**BULLETIN PA010-12**

**PART NUMBER:**  
 38332

**ACCESSORY BELT DRIVE SYSTEM  
 HONDA**

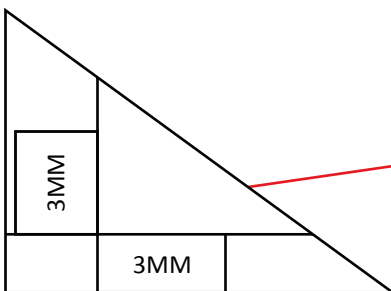
This area will need to have 3mm of material removed.

Particular V-6 applications described in Honda Bulletin 08-082 may require a small modification to the front timing cover during replacement of the accessory drive belt tensioner. (NAPA part number 38332 ) The OE now provides an updated tensioner assembly which may cause interference with the front timing cover of some applications. NAPA Belts/Hoses also offers the same, updated design as the OES. The small task is to remove approximately 3mm of plastic material from the front cover, allowing proper clearance.
